## TOWN OF YORKTOWN PLANNING BOARD

### PUBLIC MEETING AGENDA YORKTOWN TOWN HALL BOARD ROOM 363 Underhill Avenue, Yorktown Heights, NY 10598

March 28, 2022  
7:00 PM

3. **Kitchawan Solar**  
**Decision Statement Site Plan & Special Permit**  
*Location:* 70.06-1-2 & 3; 716 Kitchawan Road  
*Contact:* Ecology Kitchawan Community Solar Farm, LLC  
*Description:* Proposed 2 MW ground mounted large-scale solar energy system.

**C-2.0**  
LAYOUT AND MATERIALS  
PLAN

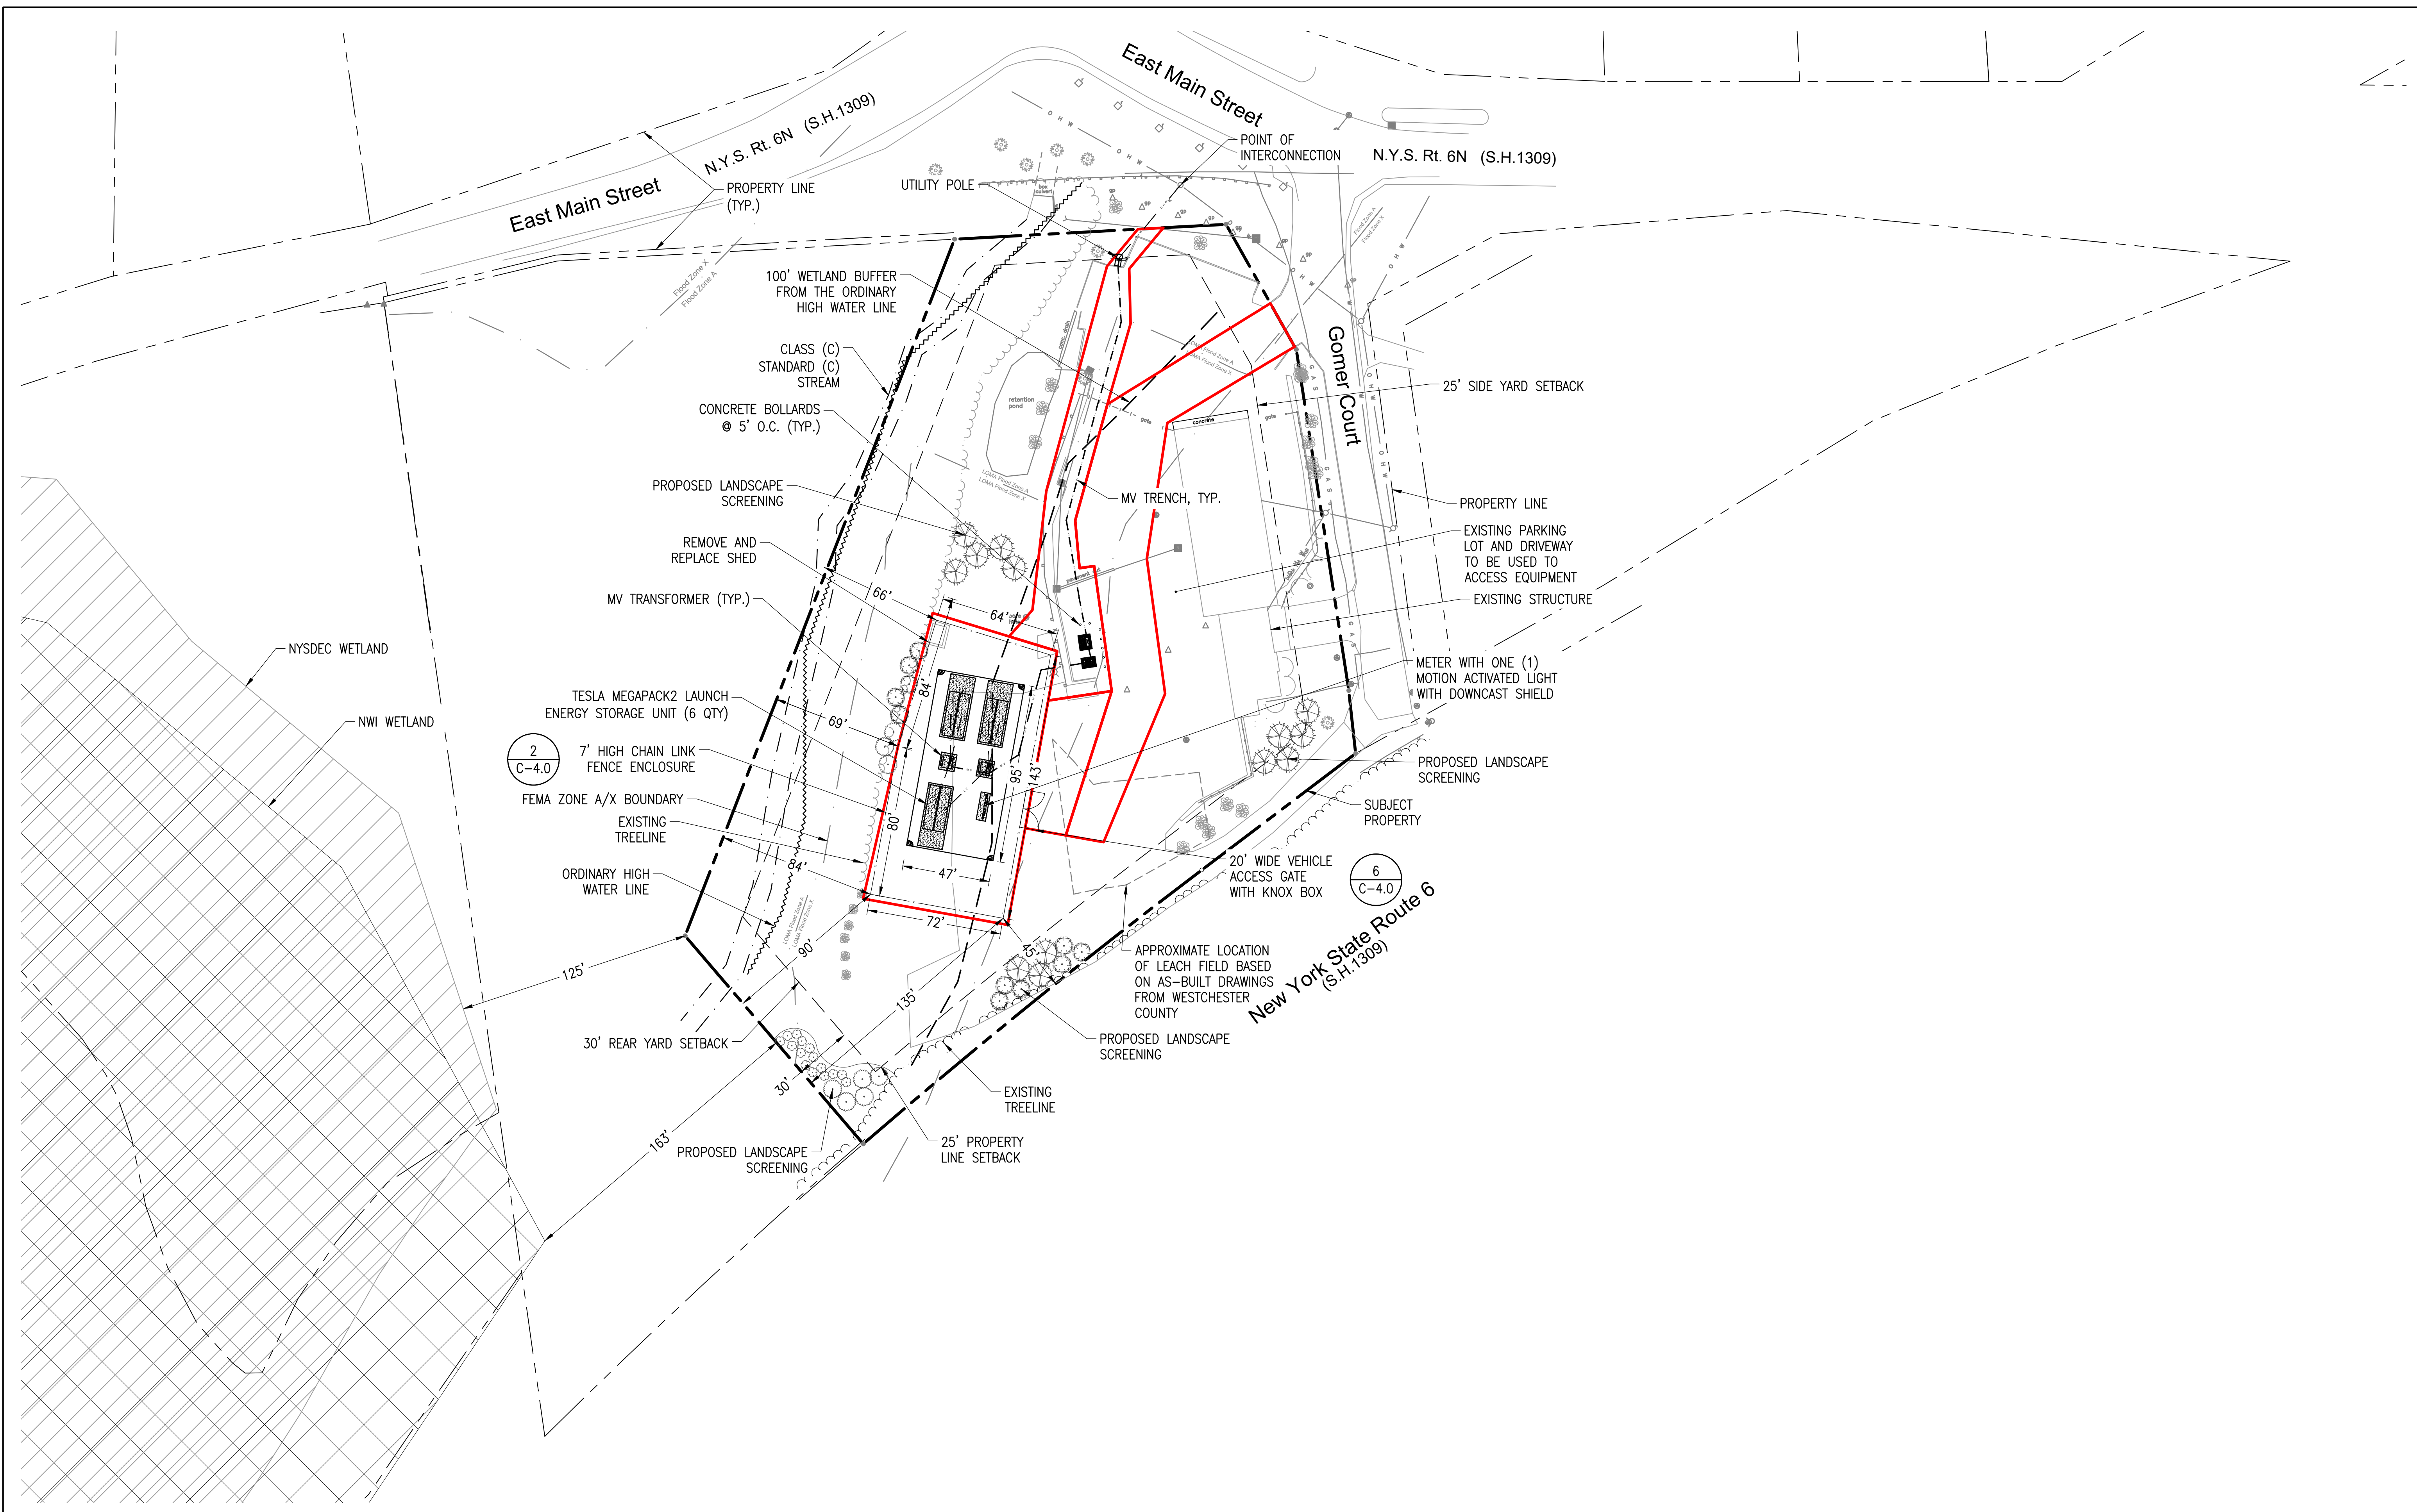
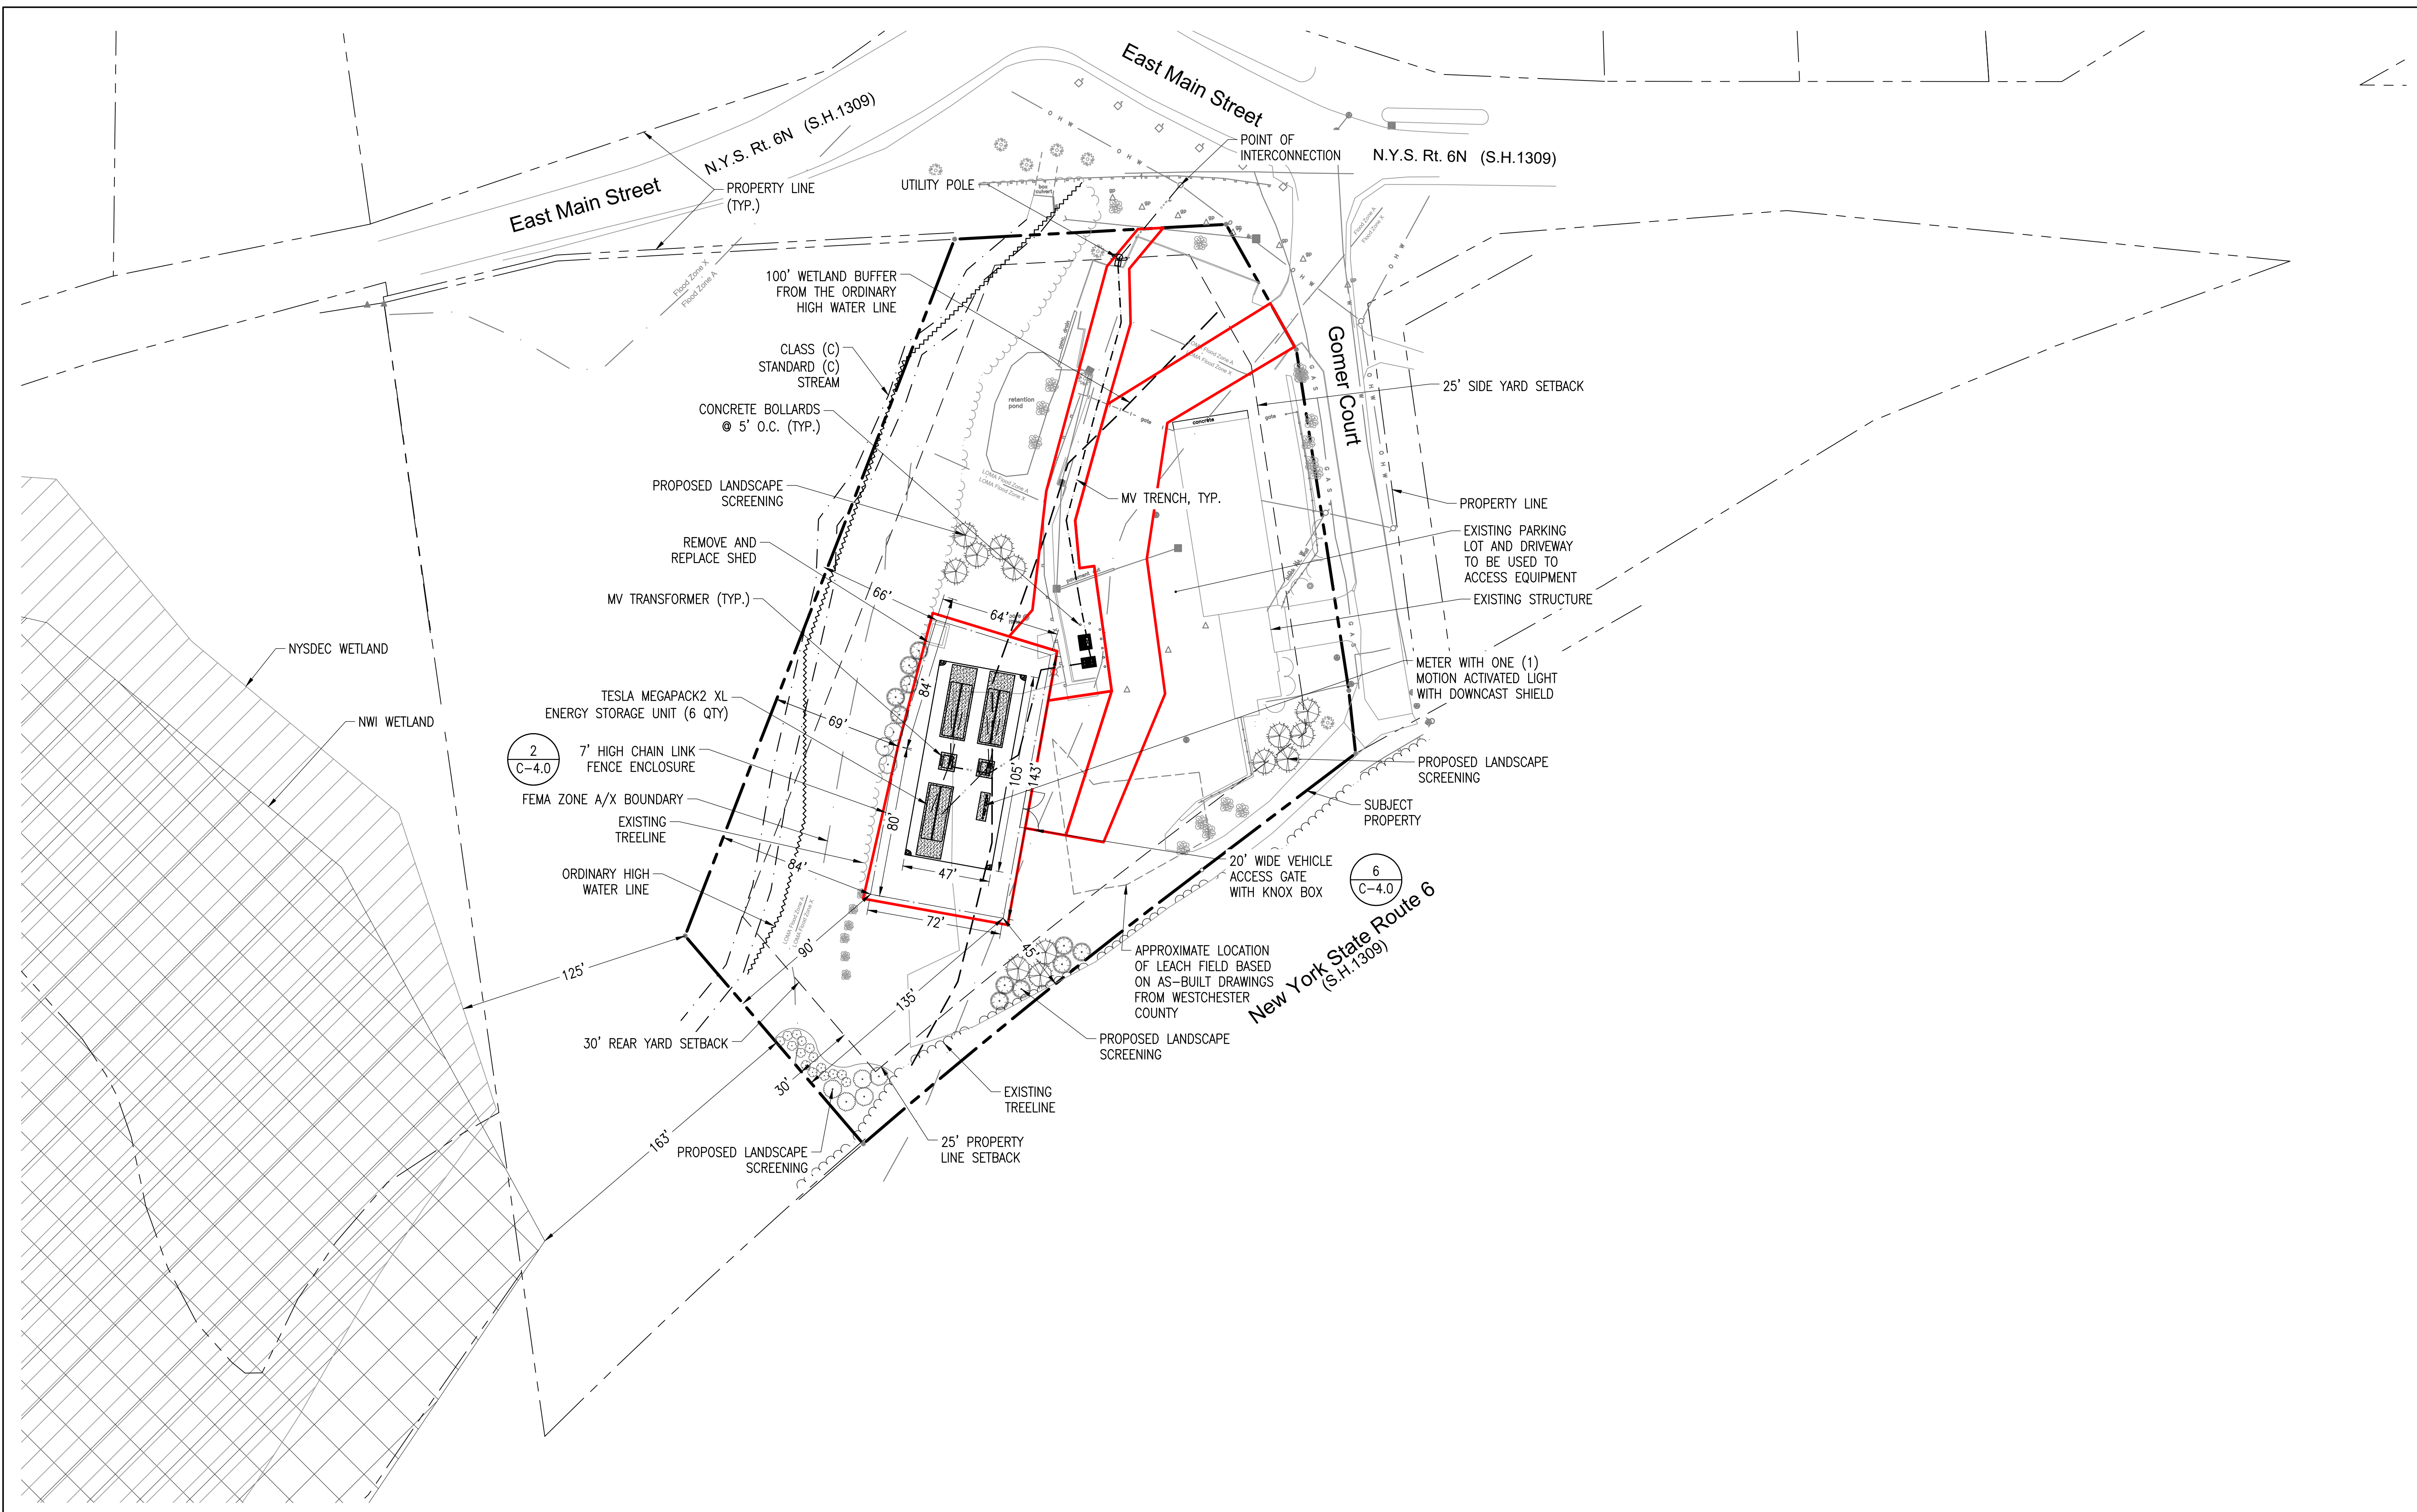
I spoke to both Robyn and Ed (copied) earlier this week about the potential change from the permitted Fluence system to a Tesla system. As promised, I am providing additional information on the potential change below. Our obvious preference would be to avoid going back through the Planning Board process due to the similar 1:1 technology replacement and system footprint, but are looking for your input on the matter.

Drawing Title: **OVERALL LANDSCAPE PLAN**

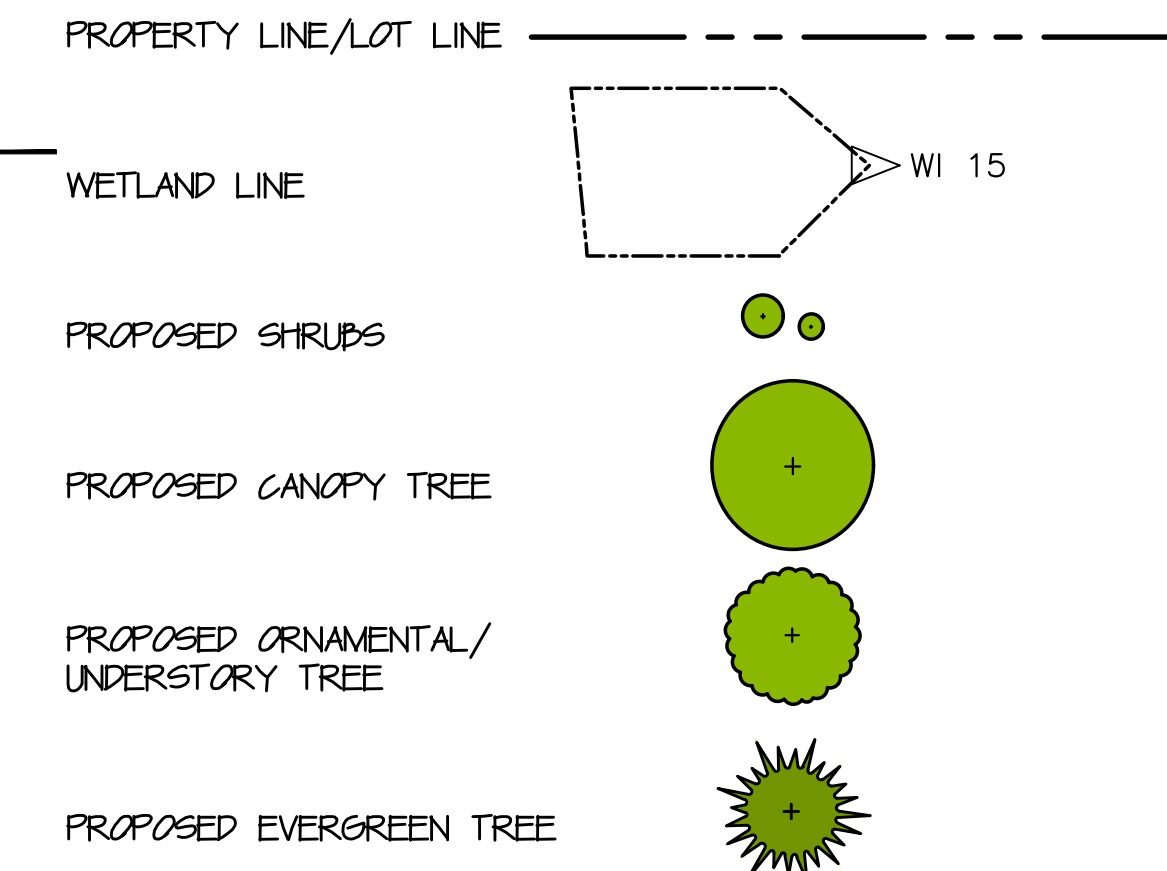
1. Ecogy has still not provided a mitigation plan. In their February response they stated that their landscape plan included "a significant number of trees and shrubs on the plans will be planted in areas of the property that do not require screening." In our 9 March 2022 memo we stated they needed "to create a separate plan showing what Ecogy considers mitigation plantings. Without such a plan, the TCAC cannot evaluate the adequacy of their mitigation. A plan showing the proposed mitigation needs to be provided." Ecogy has not complied with the requirement for the submission of a mitigation plan.

3. Ecogy has not addressed the TCAC's point 7 which states "The proposed increased diversity of the row of screening trees is, in the TCAC's view, insufficient. The original number of 85 Green Giant Arborvitae has been reduced to 77 trees. Adding 2 more White Pines and 6 White Spruces does not reduce the planting of a monoculture of Green Giant Arborvitae. Ecogy should do more to reduce such a monoculture." This issue needs to be addressed.

1. Ecogy would like to clarify a few points as they pertain to our proposed landscaping plan. First, the distinction between a landscaping plan for mitigation and a screening plan is not made clear in the solar code. The code states that “Landscape screening and buffering shall be required” and that “Mitigation for tree loss under Chapter 270, when required, will be developed”, but the code does not state that those items must be completed separately. Second, though we were not aware that screening and mitigation must be separated, it is not correct to say that Ecogy’s landscaping plan cannot count as mitigation given that a significant number of trees and shrubs on the plans will be planted in areas of the property that do not require screening. The landscaping plan includes both screening trees and additional plantings, at least some of which would count towards mitigation. Finally, given how far into the review process this comment has been made, it is not feasible for Ecogy to create a separate planting plan for only mitigation and we request the TCAC accept the landscaping plan as addressing both screening and mitigation.

6. Ecology has replaced both Sourwood trees with Dogwood trees as requested. Please see the new landscaping plans included with this memo.

7. Ecology has increased the diversity of the row of screening trees as requested. Please see the new landscaping plans included with this memo.
